Timely Signs

Burger King Restaurant 80 Route 17K Existing Signage:

PROJECT: BURGER KING REMODEL

Code Compliance
CALCULATIONS

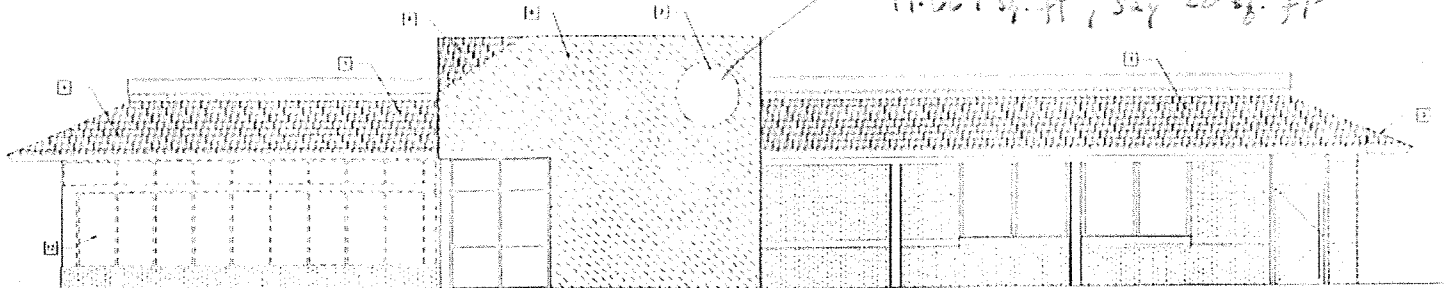
Pylon Sign: 8' x 8' Logo + 4' x 8' Readerboard = 96 Sq. Ft. $\times 2 = 192$

Existing Pylon Sign: 96 Sq. Ft. $\times 2 = 192$

~~Total Existing = 156 Sq. Ft.~~ 252

~~Total Proposed = 178 Sq. Ft.~~ 274
